REVISION NO. 6 **JUNE 24, 2016**

THE MEDICAL CENTER OF AURORA RENOVATIONS
Aurora, Colorado

ESa PROJECT NO. 14077.00

These revisions form a part of the Contract Documents and modify the original CONSTRUCTION DOCUMENTS, dated December 30, 2014, as outlined here in addition to being shown on the drawings as Delta No. 6, dated June 24, 2016.

FIRST FLOOR PATTERN PLAN PART A

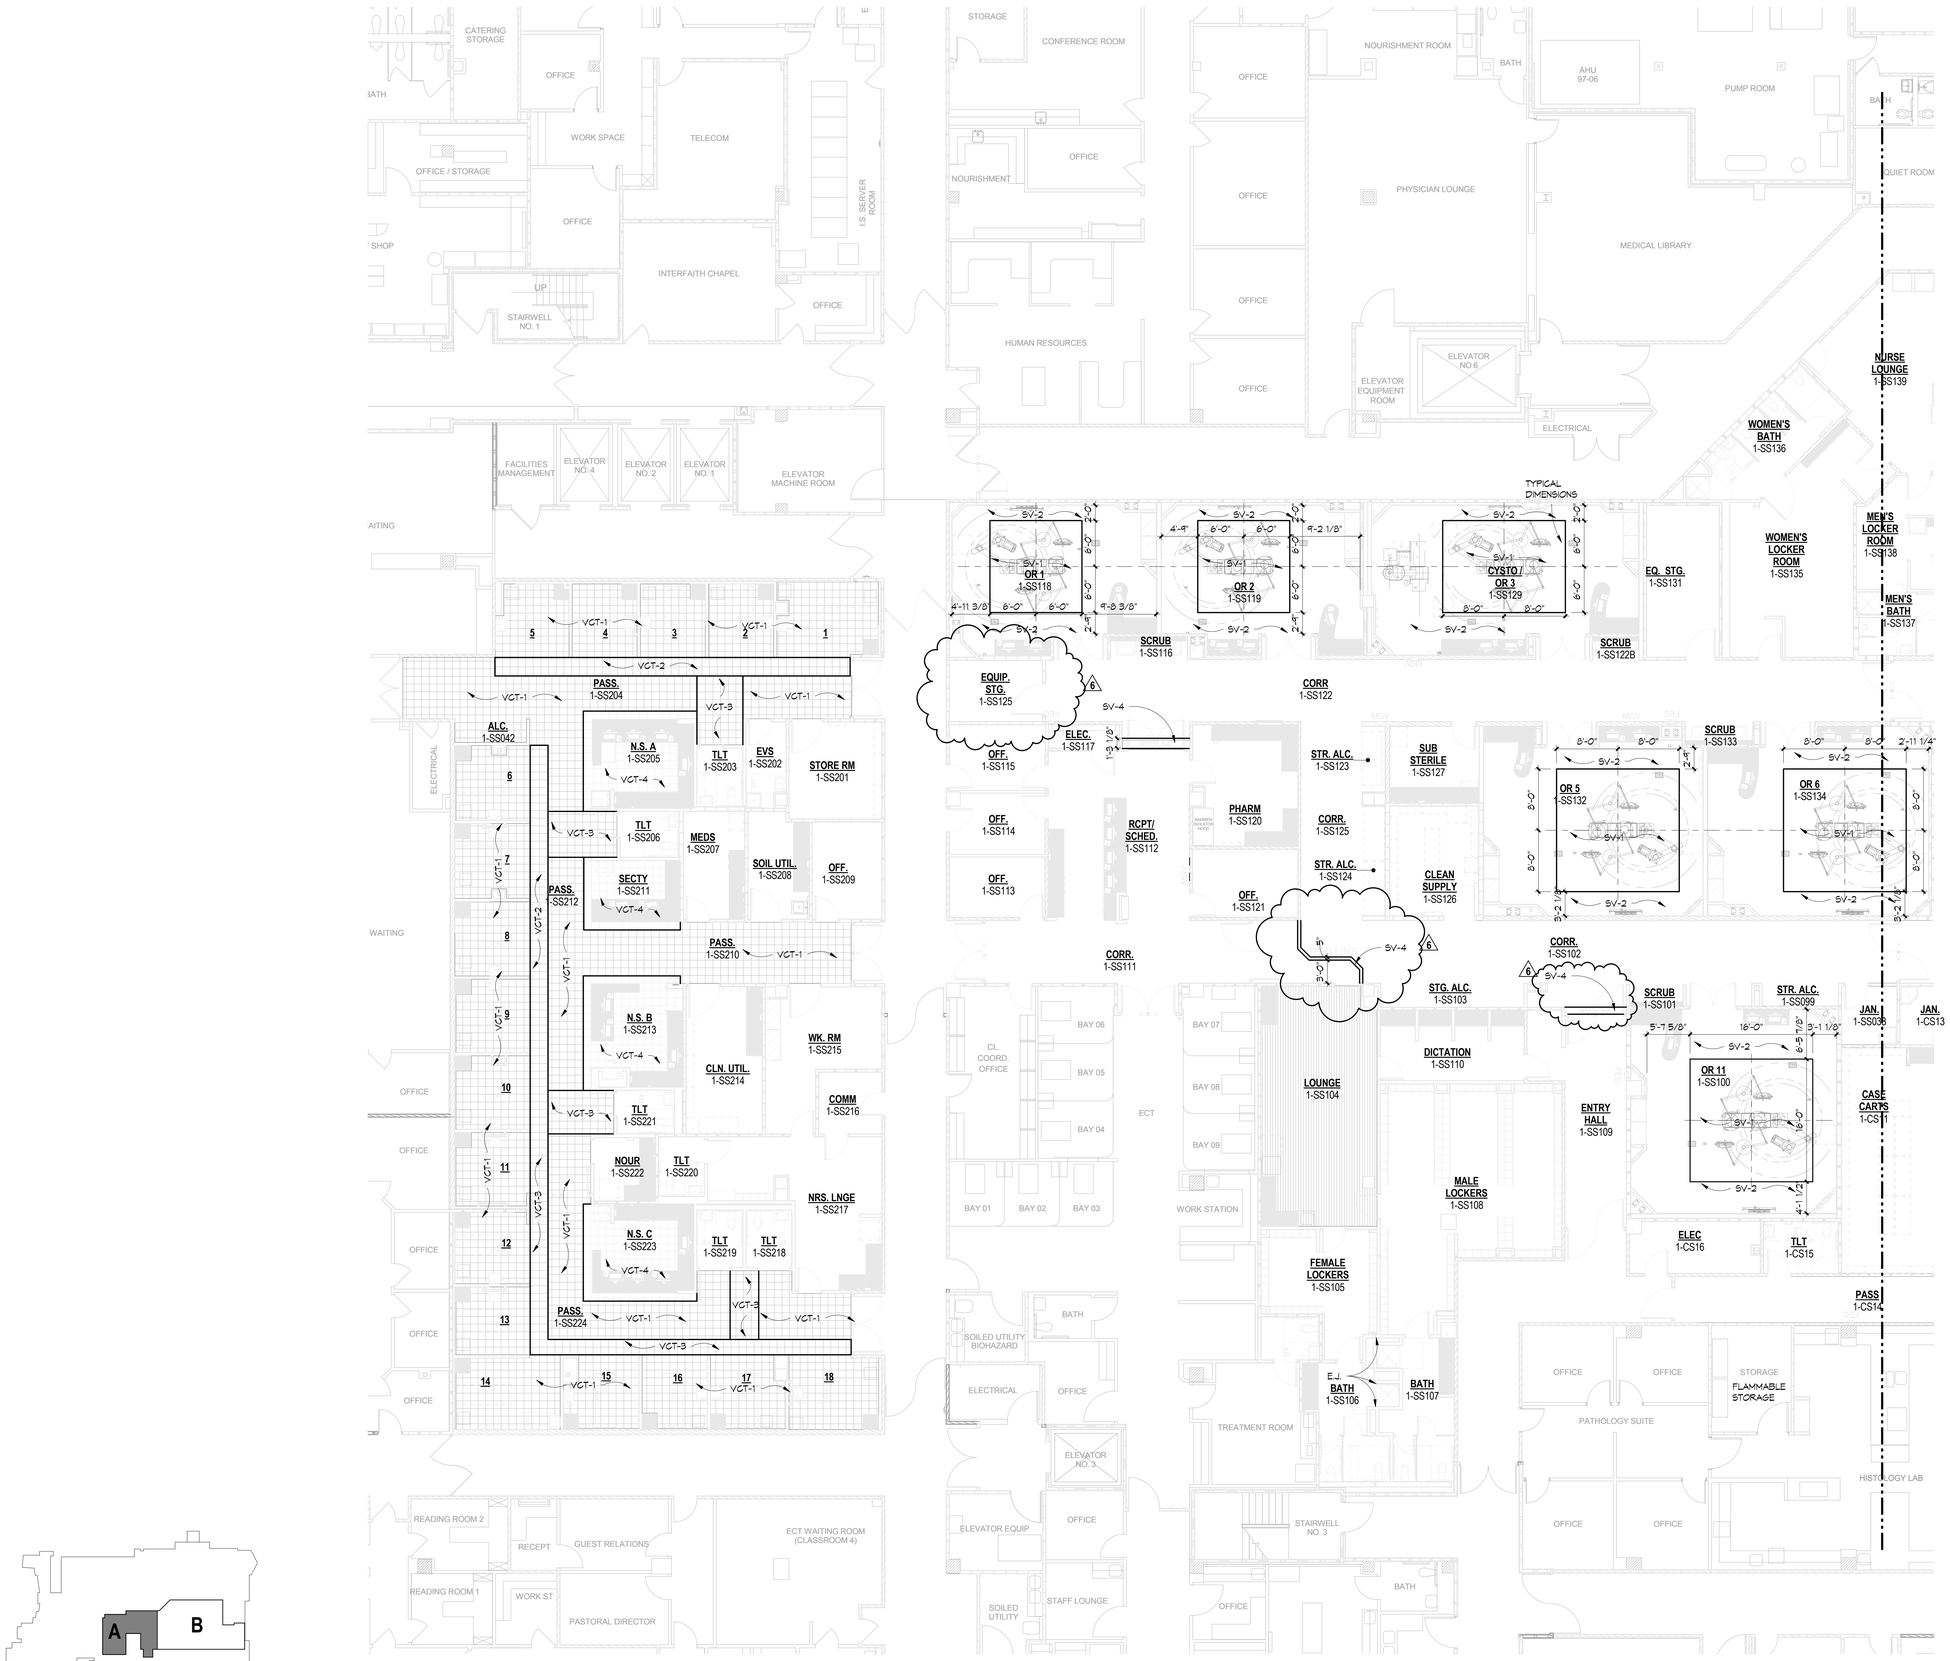
1. Adjusted Redline per Owner request.
2. Plan updated per layout changes.

F3.01A

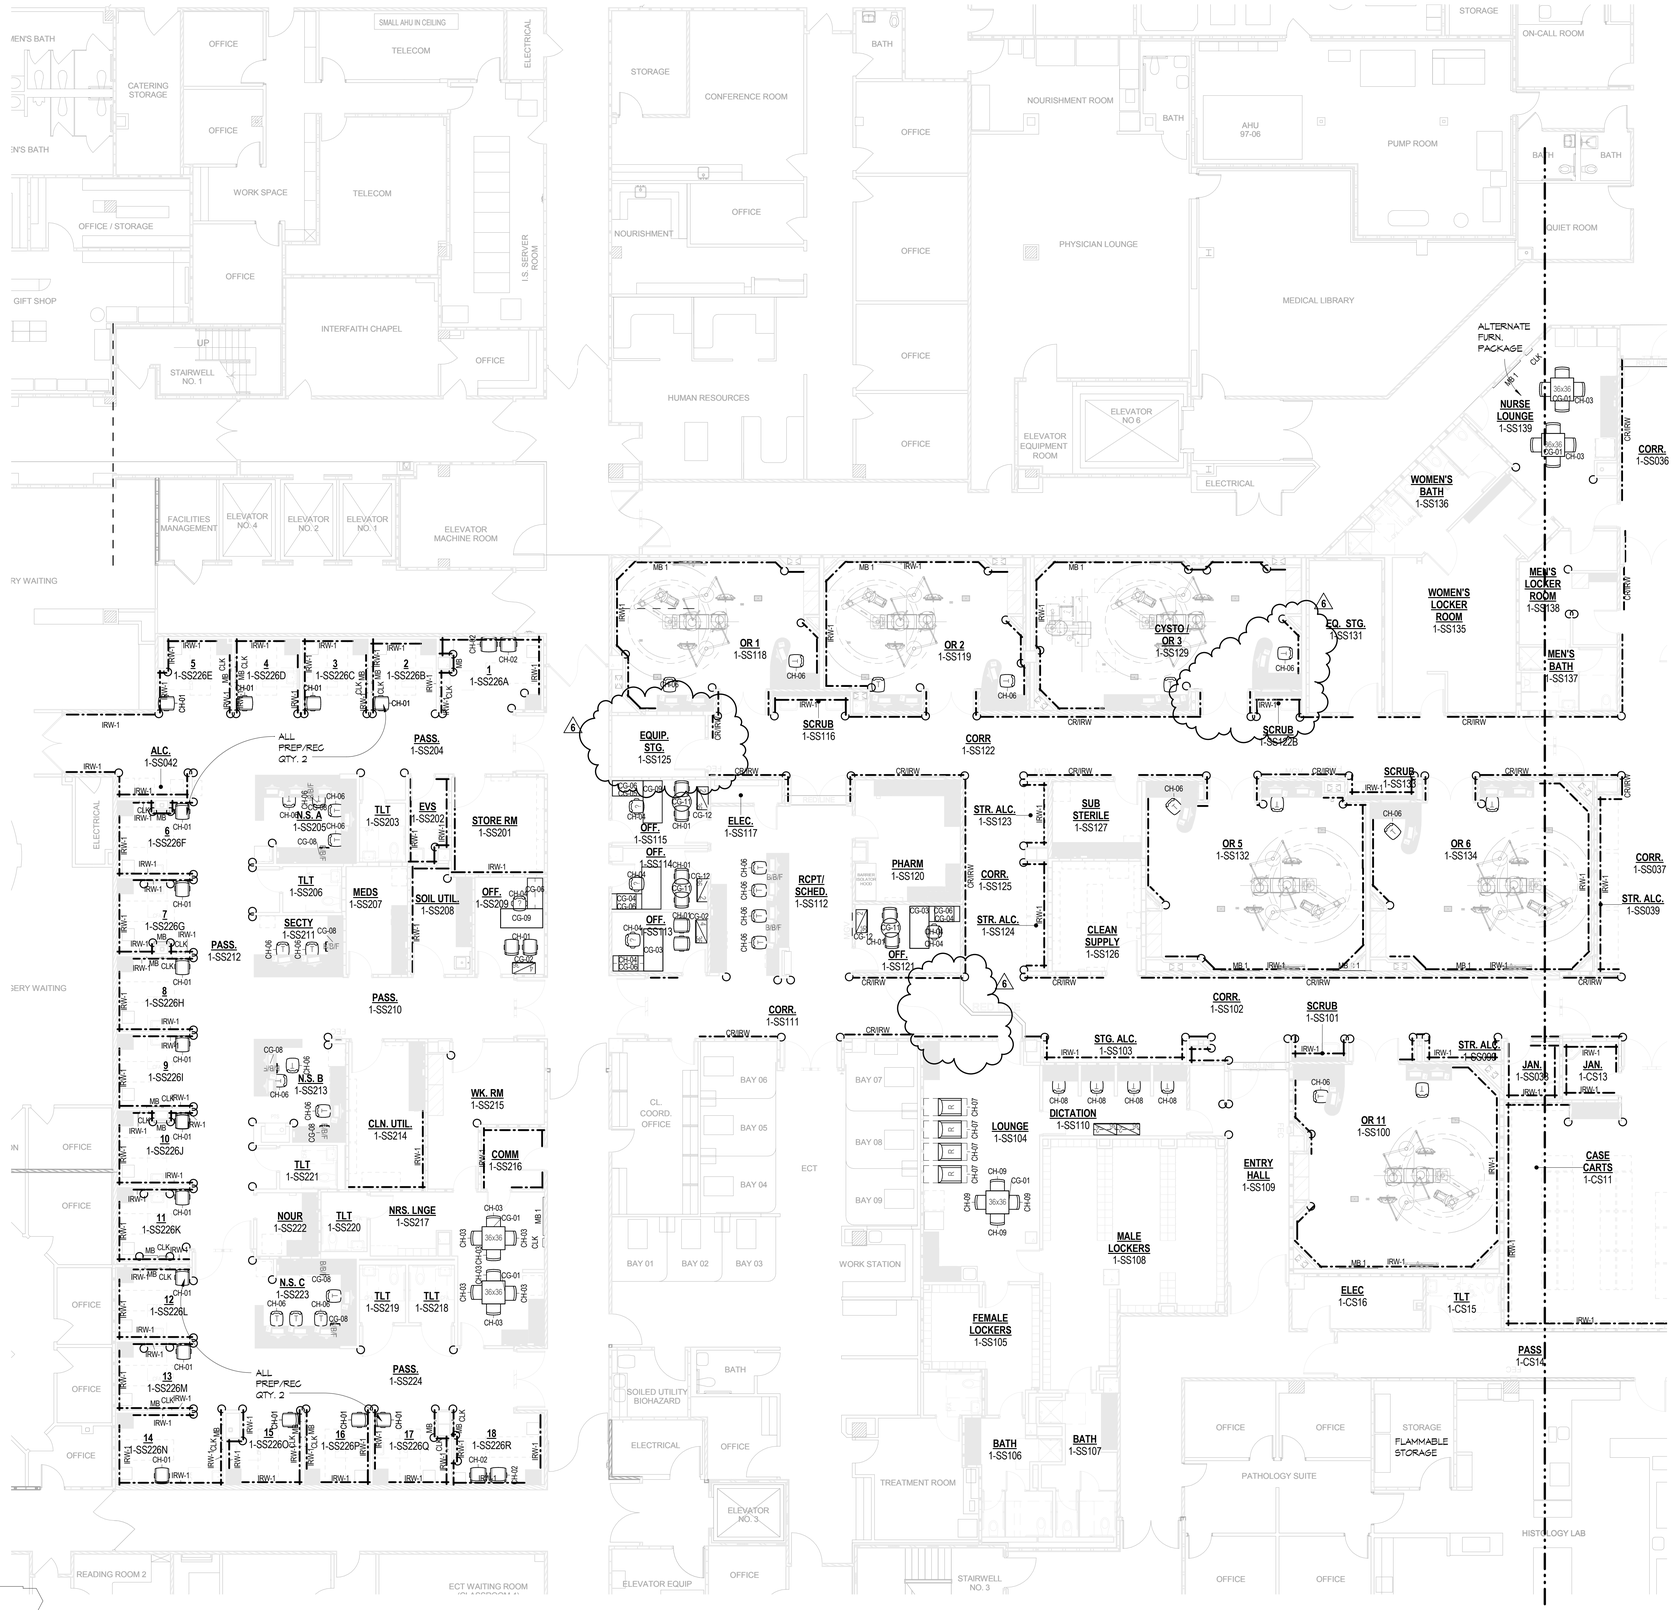
1. Wall protection updated per plan adjustments.

F3.01B

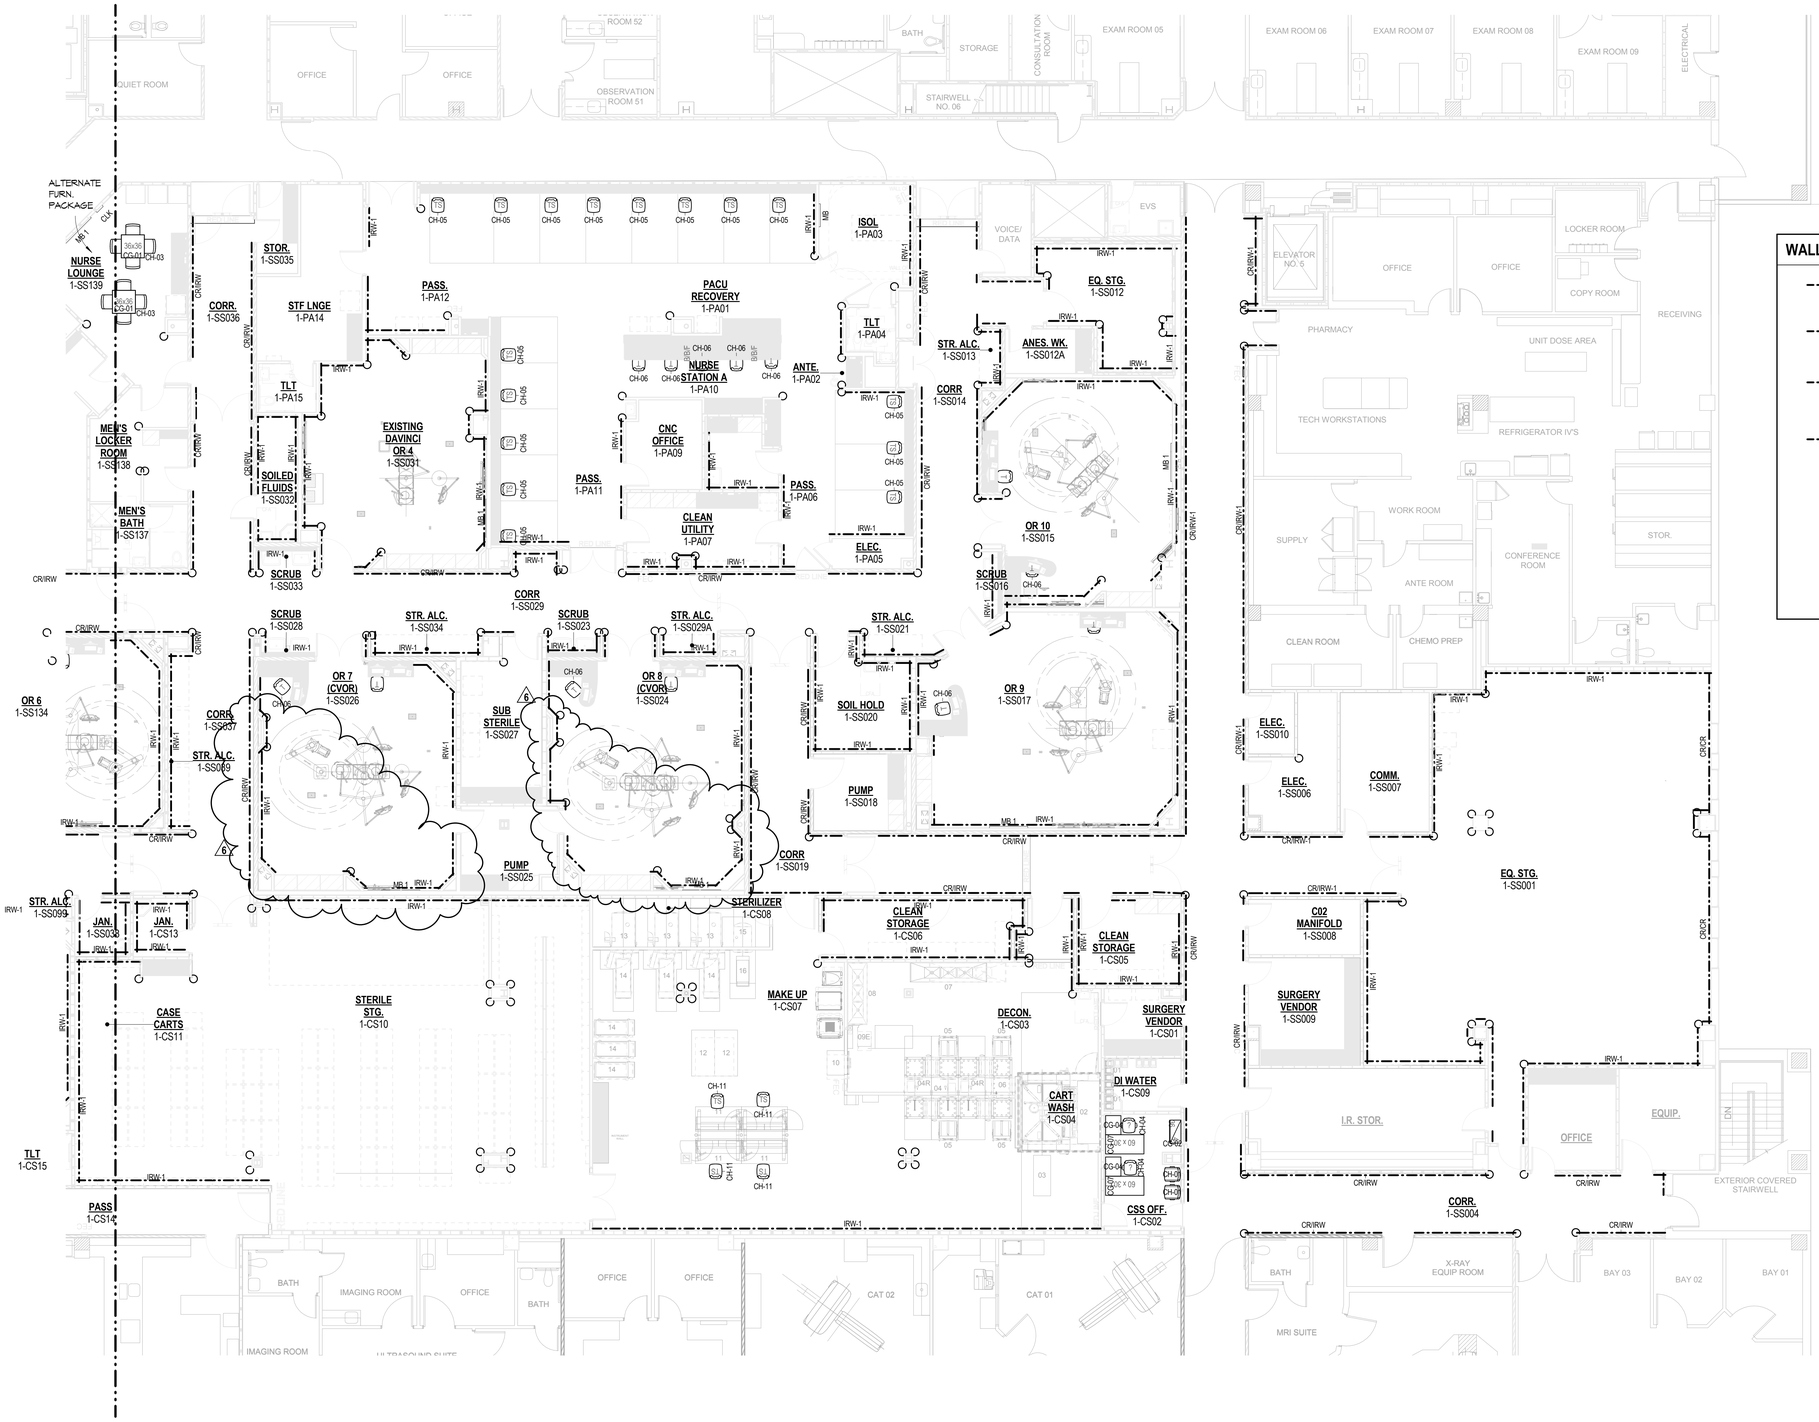
1. Wall protection updated per plan adjustments.

FIRST FLOOR SIGNAGE PLAN - PART A

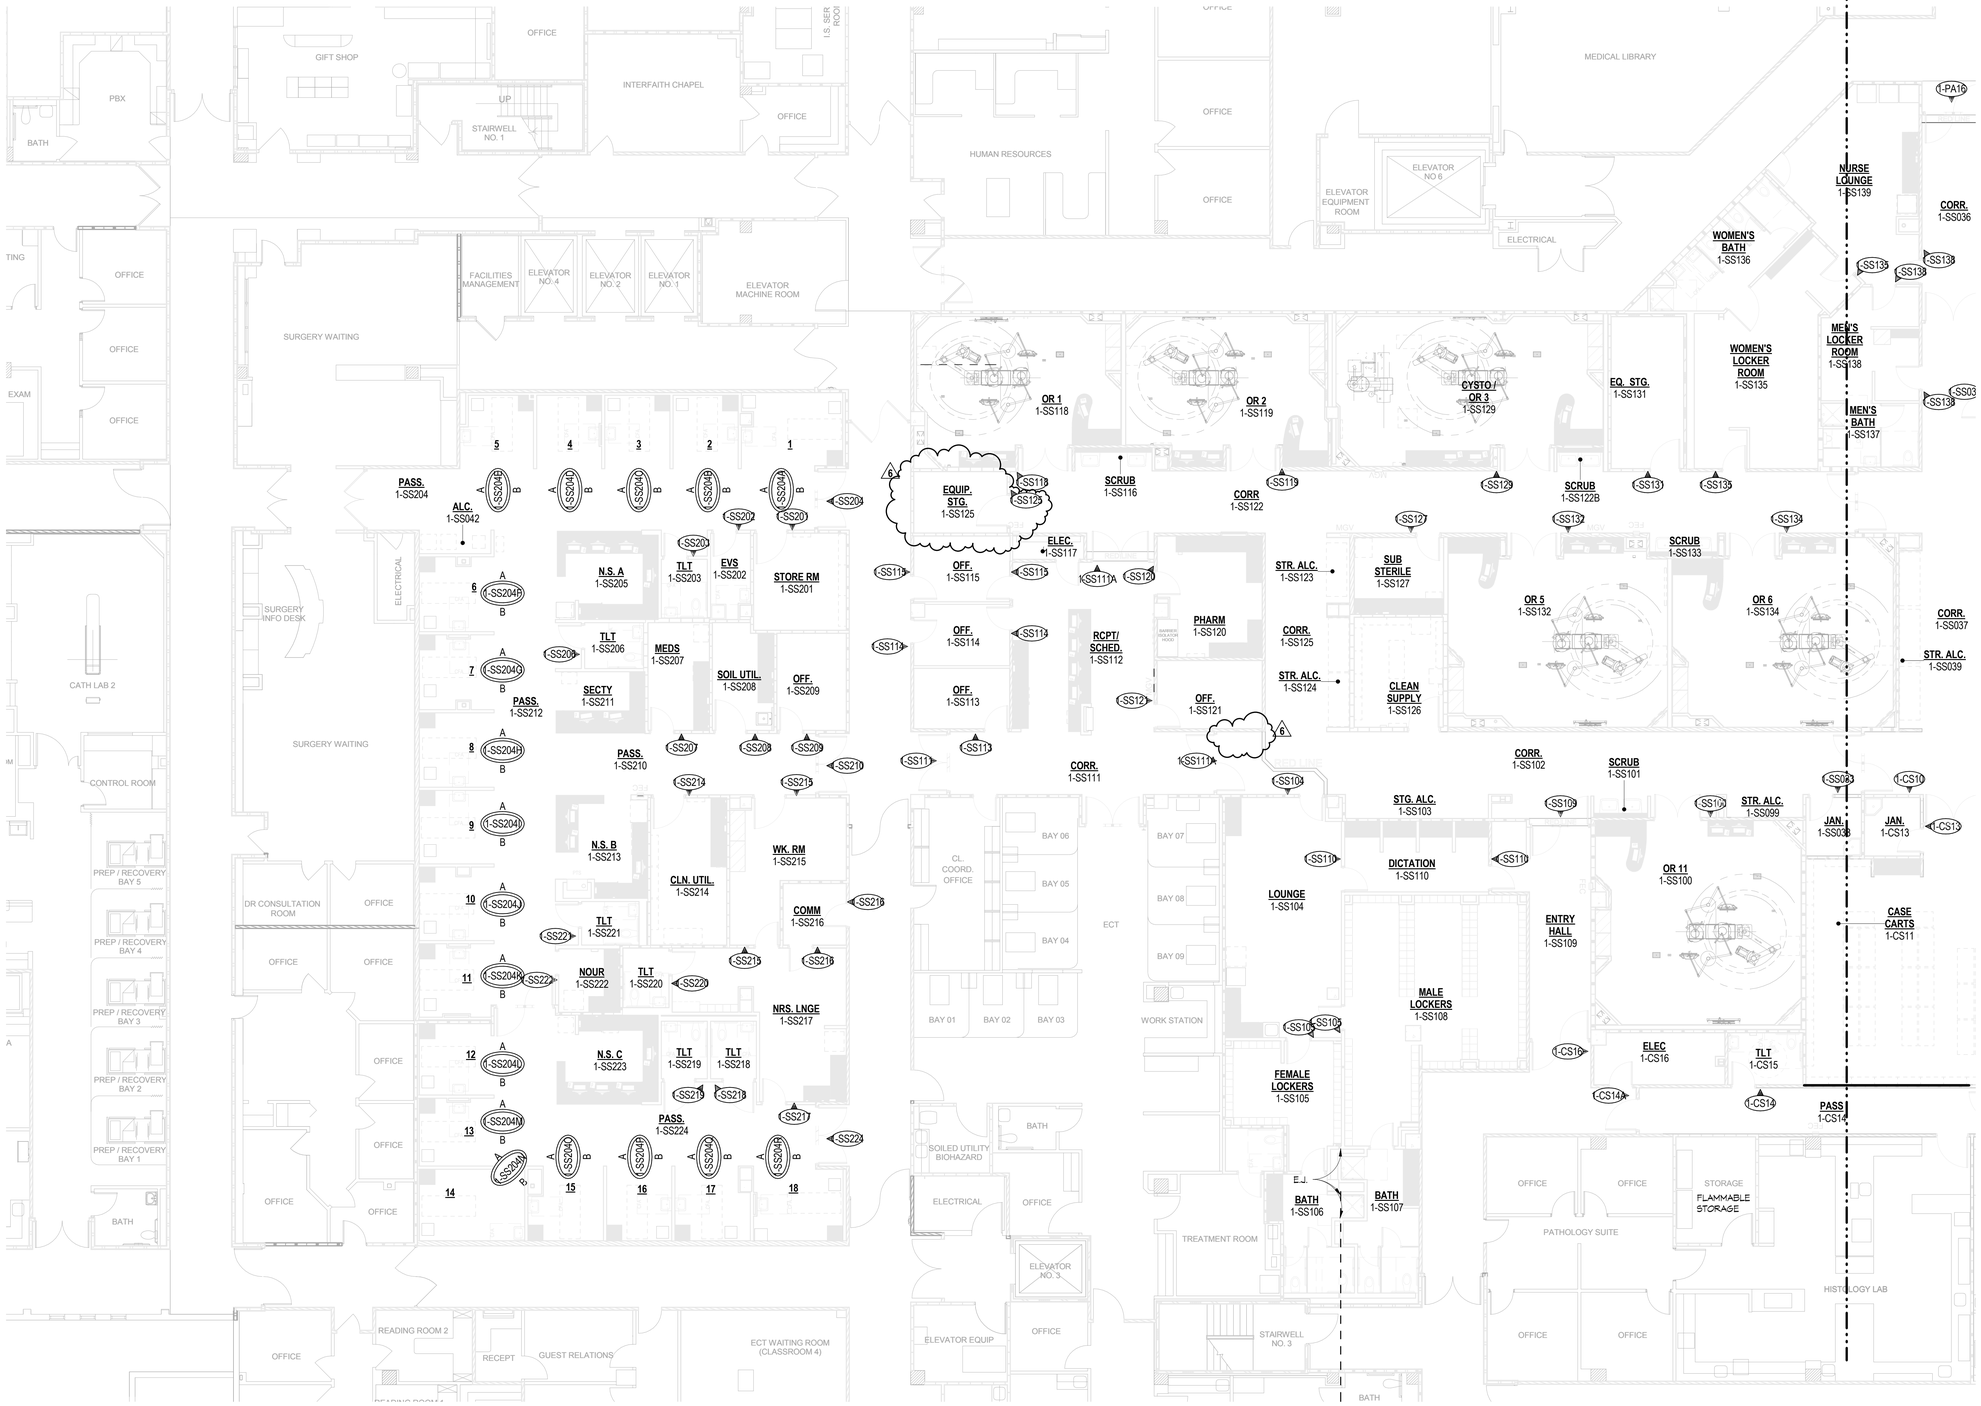
1. Signage updated per plan adjustments.
